E4416A-11A

S E R V I C E N O T E

Agilent E4416A EPM-P Peak & Average Power Meter

Front Panel Display Problems Caused by Power Assembly Cable

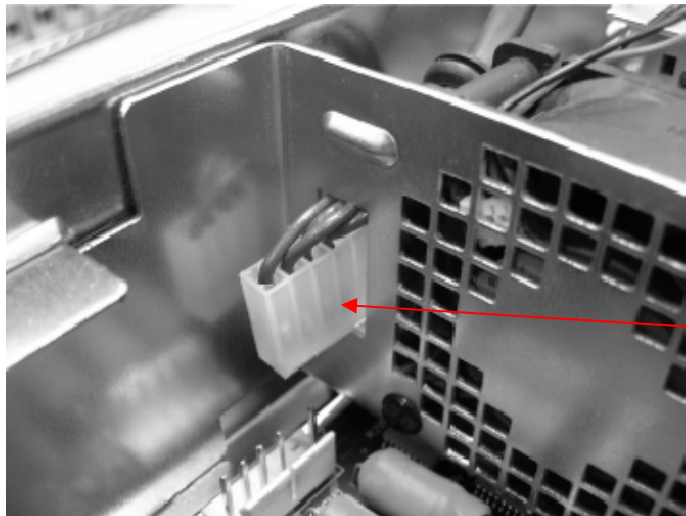
- 3) Remove fan connector and PSU cable assembly and replace with new PSU cable assembly E4418-61005. You can differentiate the cable assembly by the colors. The old cable is Black and new cable is RED.

Fan connector

PSU cable New cable is RED in color

Insert the plastic casing horizontally

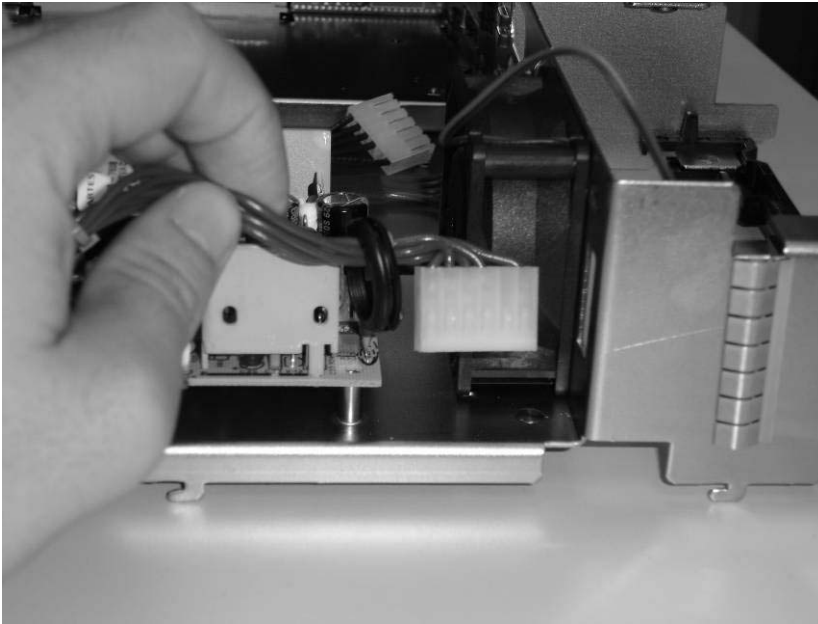
- 5) Here are some tips regarding the new cable. Since the plastic casing is slightly bigger in size, so you cannot directly pass through connector through hole. So you need to insert the cable horizontally. See illustration below.

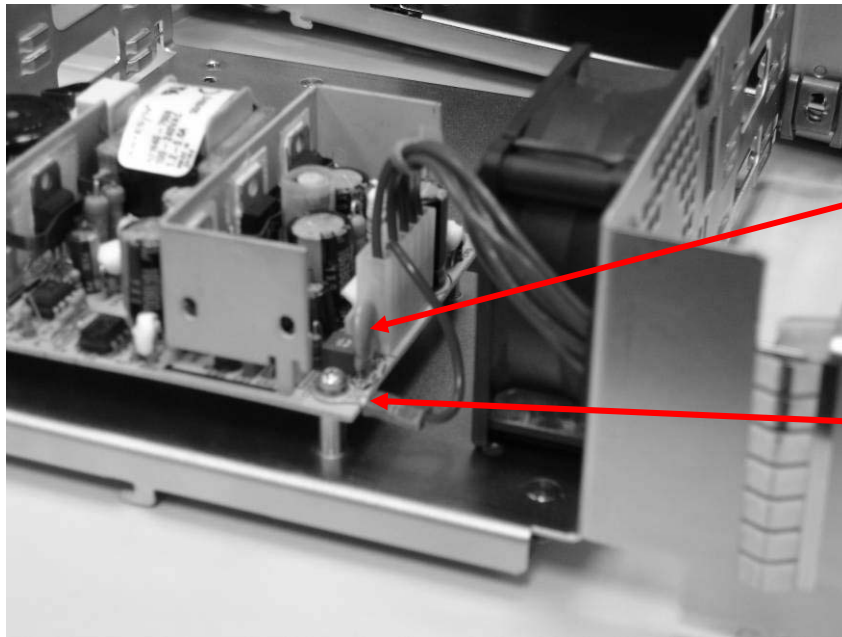
7) Photo below show different of old and new cable. The new cable is red in color whereas the old cable is black in color. The E4418-61005 has 1 ground wire.

New cable assembly

Old cable assembly

Note: If the power cable assembly is red in color, indicates that the cable already been changed. No action is needed.

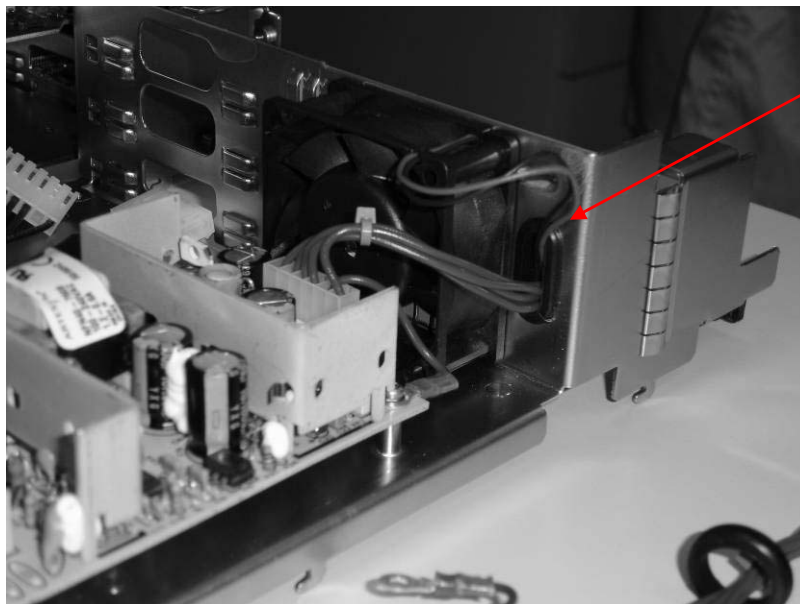
Yellow
Capacitor.

Ground wire
connected to
PCB

10) This picture above shows the ground wire connection to the PCB. Please be aware that the ground connection is very close to the leg of the yellow capacitor. PLEASE DO NOT LET THE GROUND WIRE TOUCHES THE CAPASITOR'S LEG.
